## 2.2.1 AMENDMENT 9: CPH

### CPH North & South stairwell cladding and rooftop balustrades reconfigured

APPROVED ELEVATION  
Drawing: 19555-CPA North Elevation

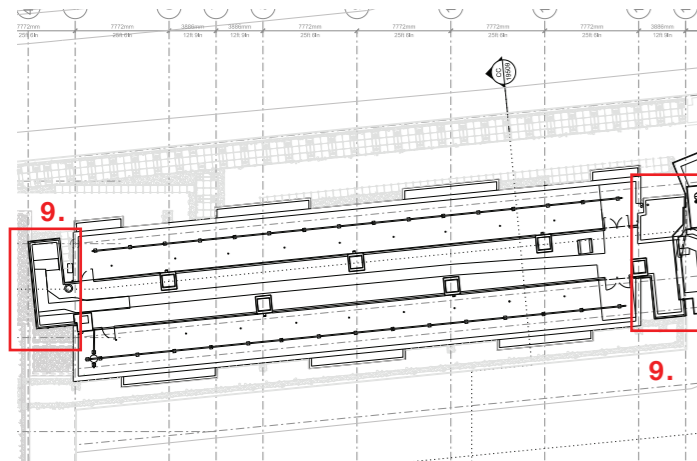
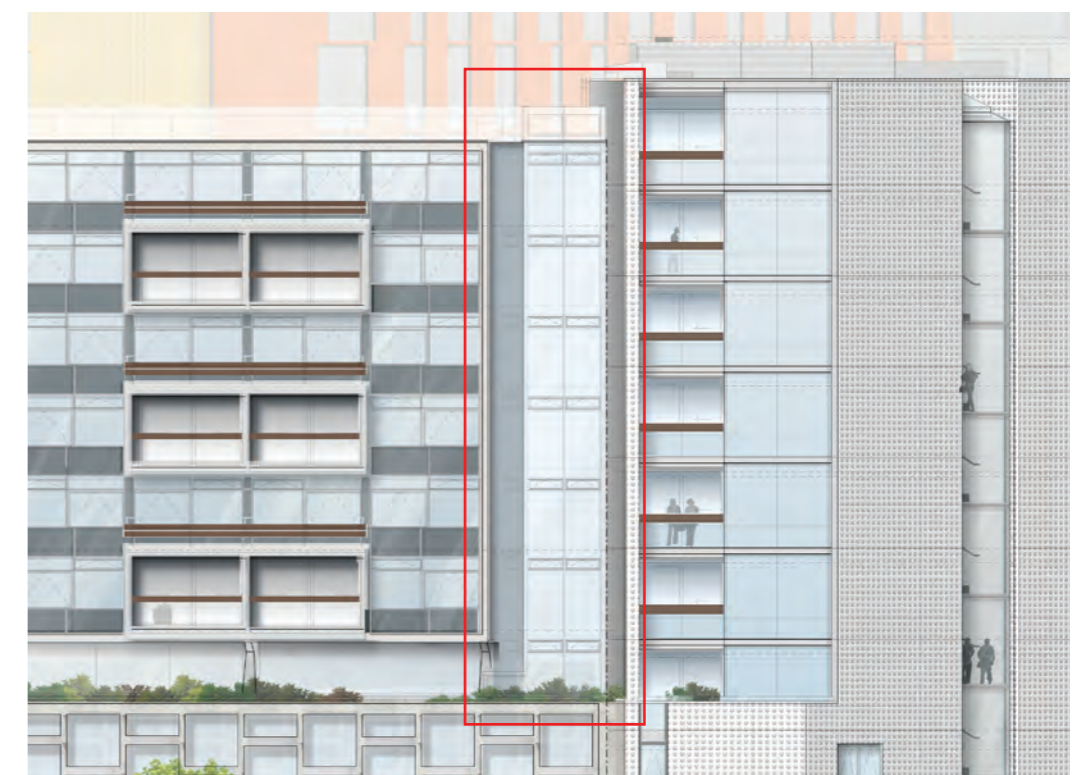
Current planning permission is based on the existing glazing to the CPH residential block being replaced with a matching curtain walling system. This currently extends above the roof line to replace the existing glass balustrades.

After further discussions with The 20th Century Society it was agreed that the existing North & South stairwells would benefit from a similar treatment that 'mimics' the existing configuration. This includes continuing the cladding above roof level to form glazed balustrades. The elevations have been updated to reflect this preferred configuration.
